RE: Comment Response Letter
Wilshire Hills Phase III
NE Wilshire Drive
Lee's Summit, MO 64064

Please find enclosed the civil related comment responses for Wilshire Hills Phase III Construction Document review submittal. Comments were received on December 15, 2023. Below are responses to site plan review comments received.

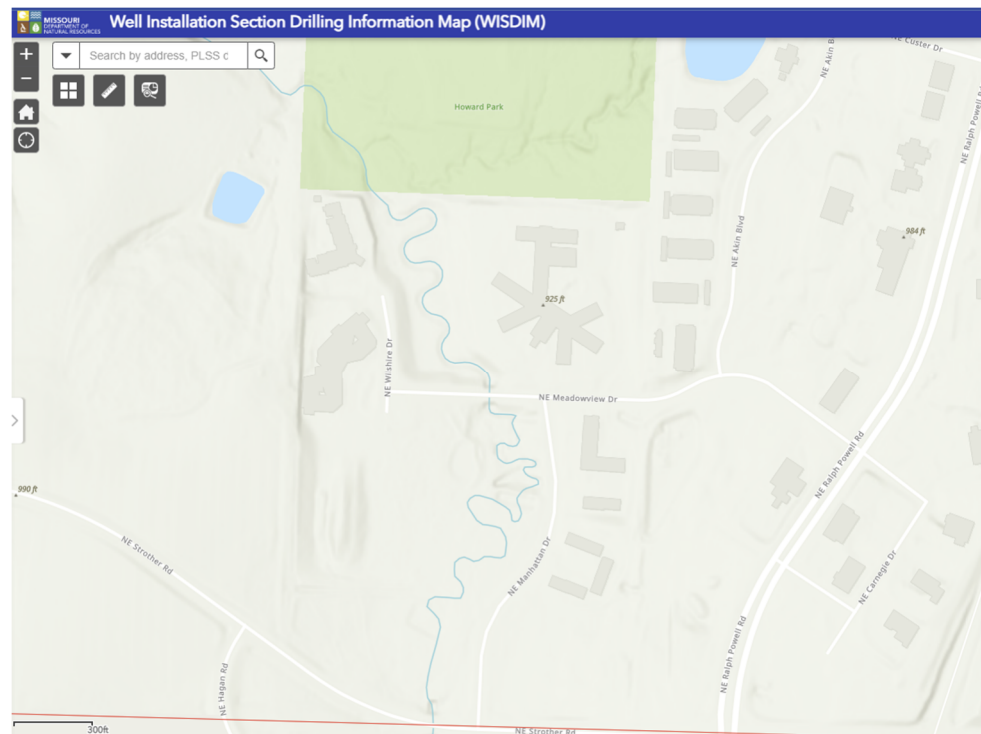
- a. *Slopes have been added to the plans.*
4. **OIL & GAS WELLS.** Add a note to the plans regarding the presence of any active, inactive or abandoned oil and/or gas wells on the subject property. Cite the source of information used to make this determination. The Missouri Department of Natural Resources has a database of wells that can be used and cited as a resource.

- a. Note has been added to page C0.02. The following image is proof that no wells are shown on the MDNR database of wells in the design area.
